**RECONSTRUCTION OF ENCINA AVENUE
FROM MIDDLEFIELD ROAD TO END**

**COUNTY PROJECT NO. RW703
PROJECT FILE NO. E5044000**

ADDENDUM NO. 1

D TYPE 24-10S GRATE
19 WELDED STEEL (RETICULINE TYPE)
AT INFILTRATION GALLERY 3
NOT TO SCALE

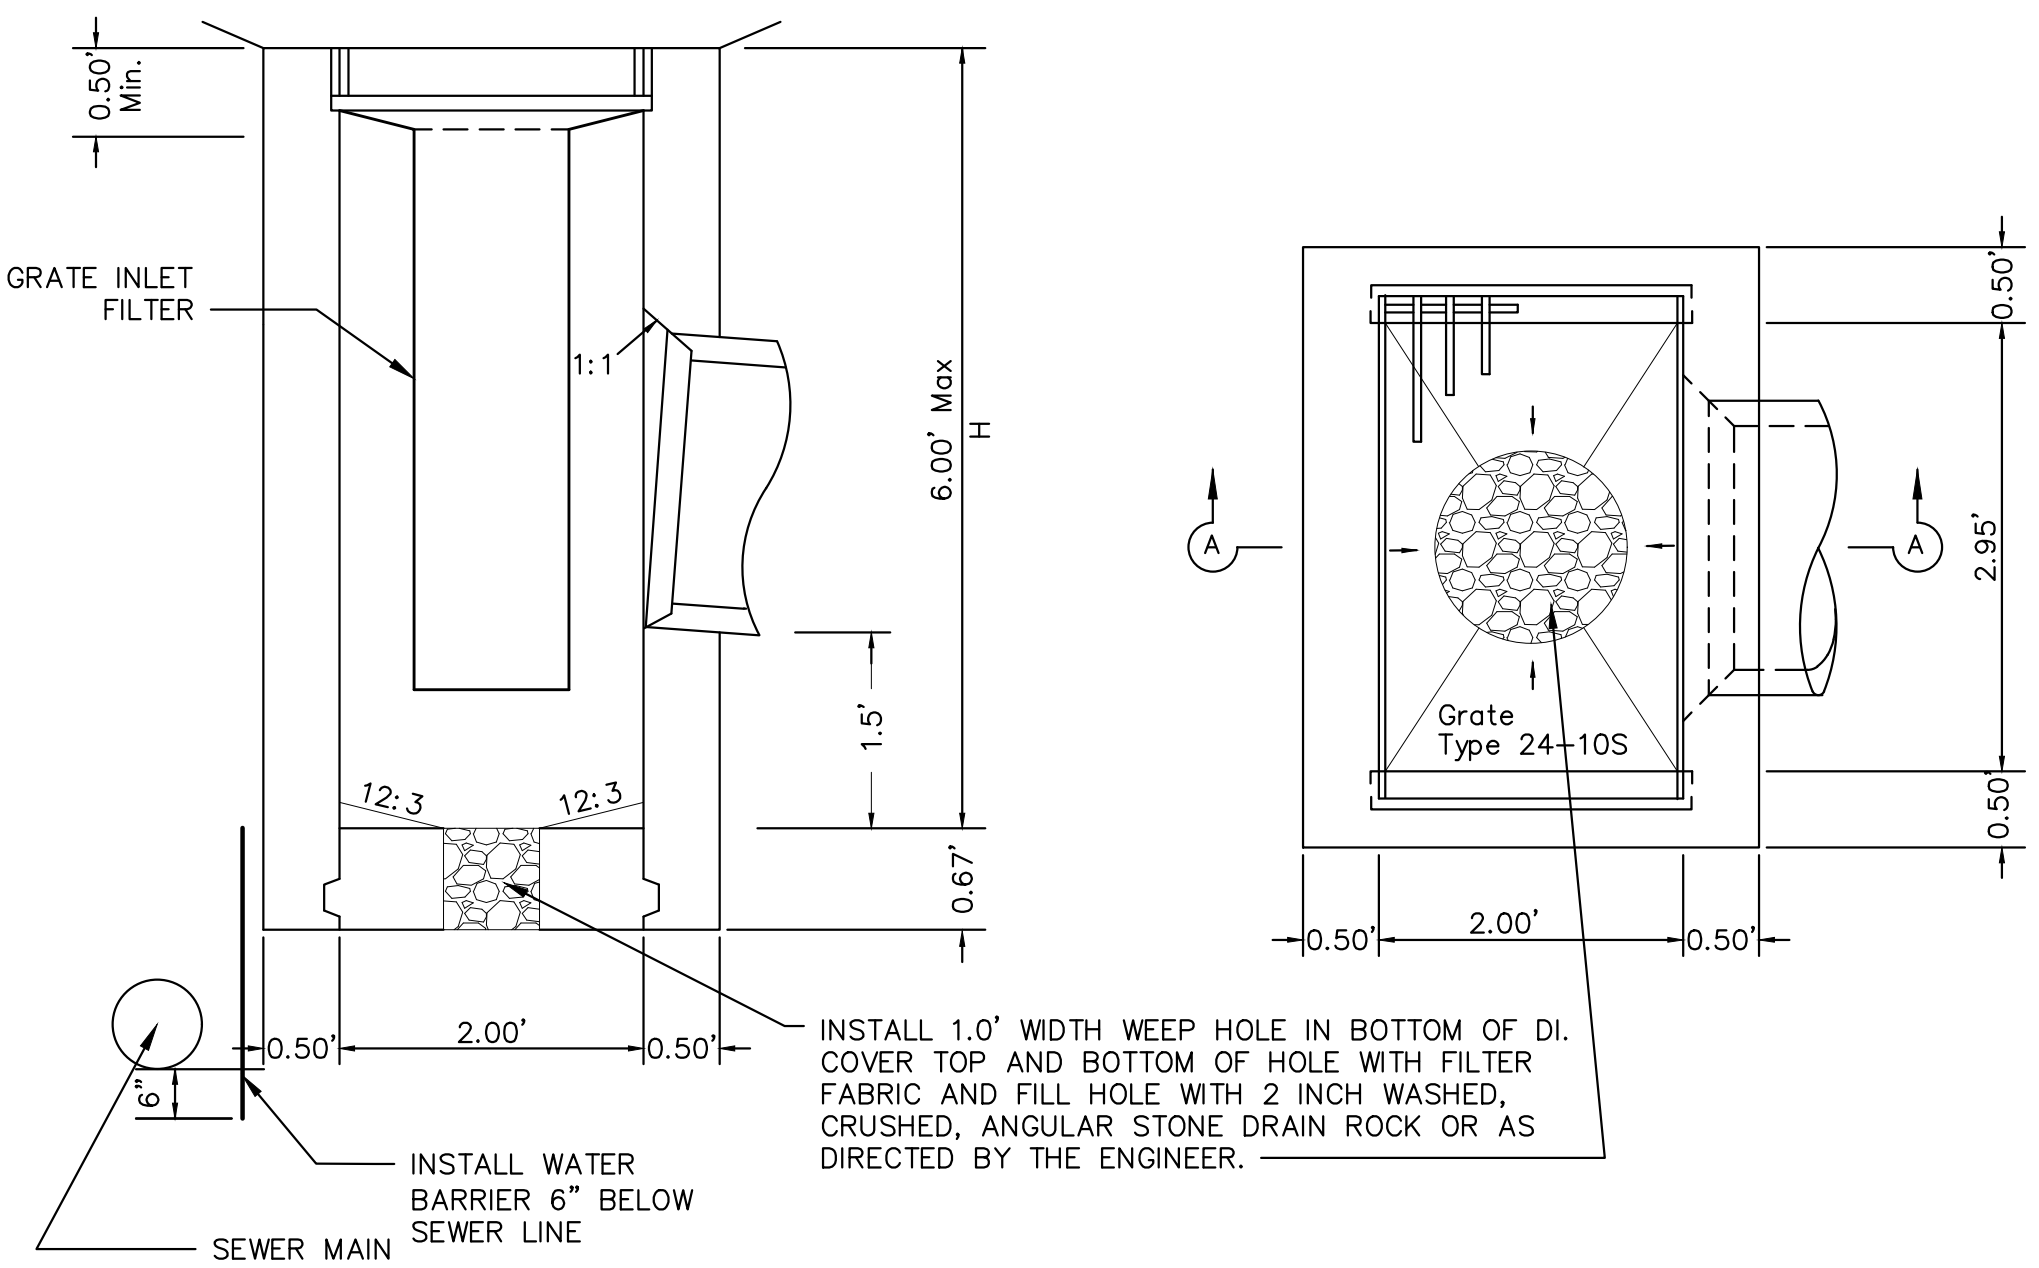
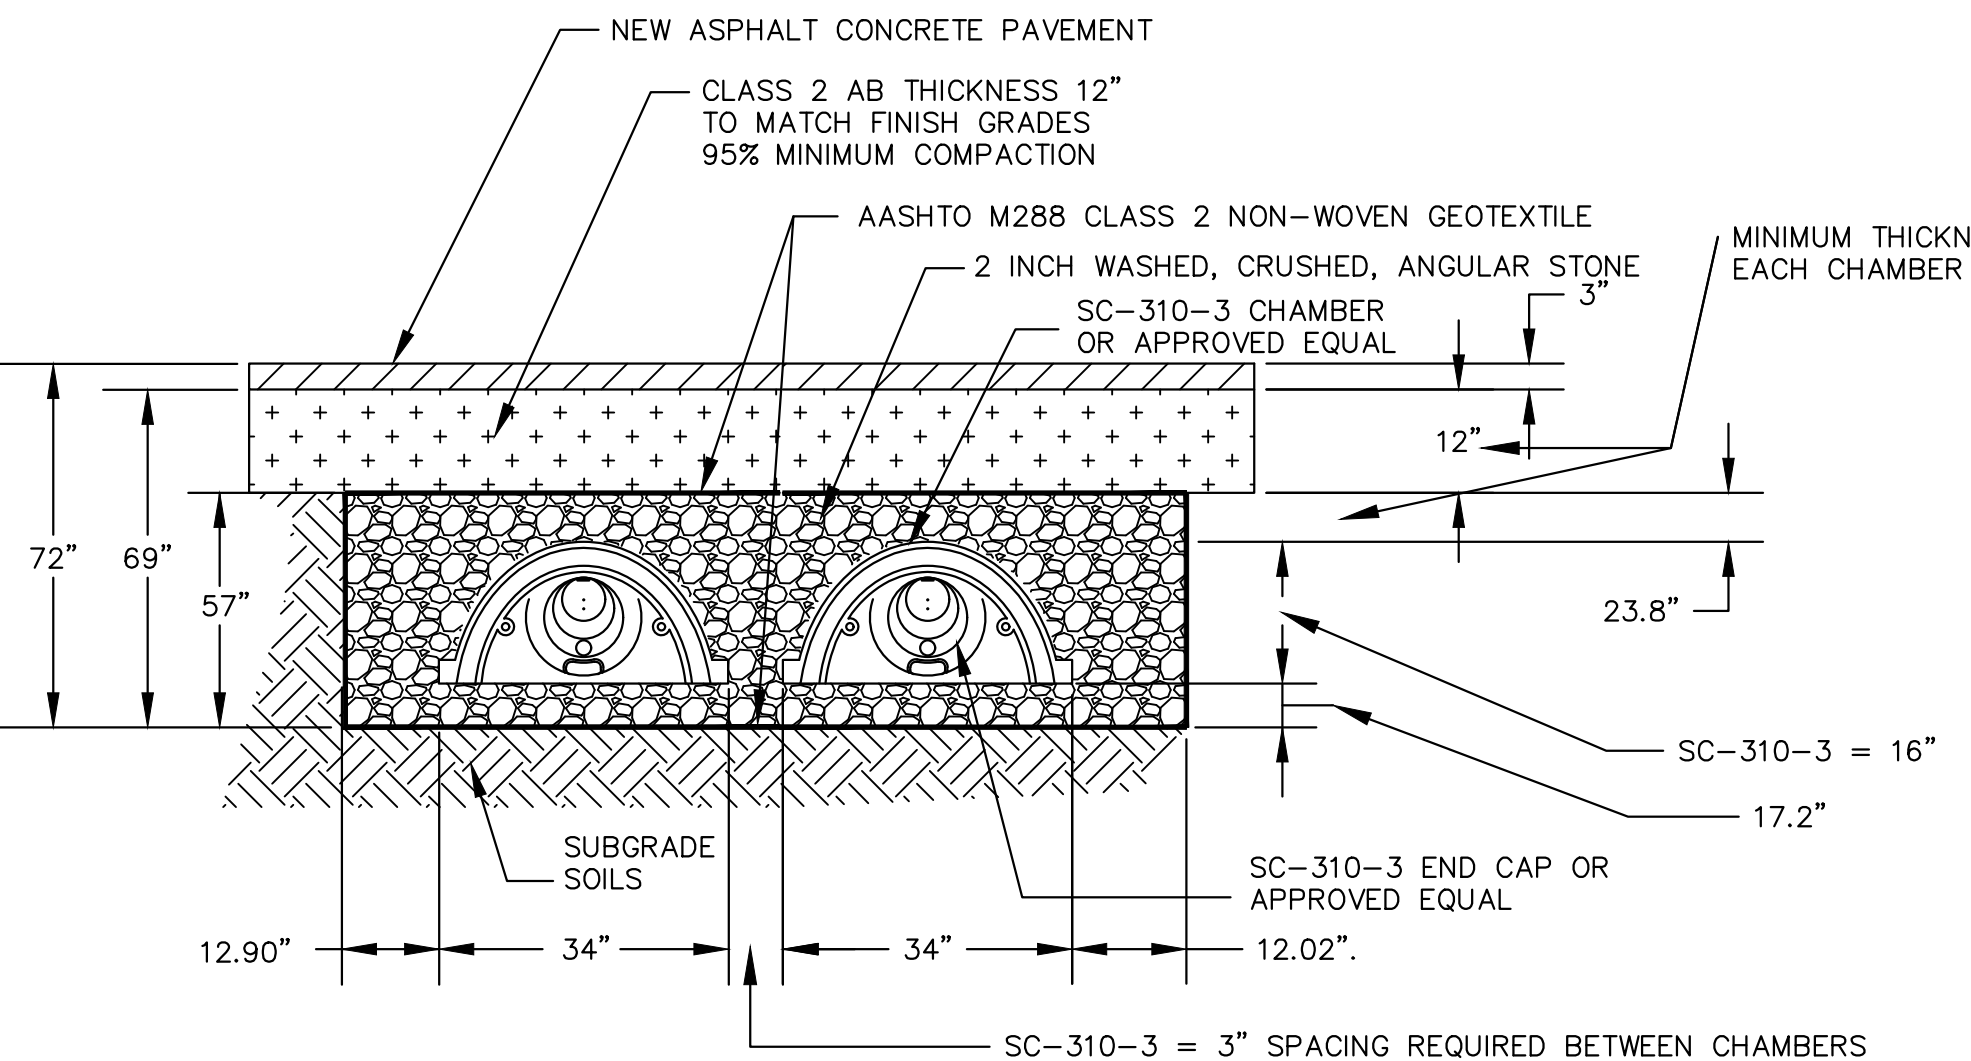
- UPDATES:**
- LENGTH, ELEVATIONS AND LOCATION OF INFILTRATION GALLERY, CATCH BASINS, STORM DRAIN MANHOLES AND STORM CHAMBERS

- UPDATES:**
- LENGTH, ELEVATIONS AND LOCATION OF INFILTRATION GALLERY, CATCH BASINS, STORM DRAIN MANHOLES AND STORM CHAMBERS
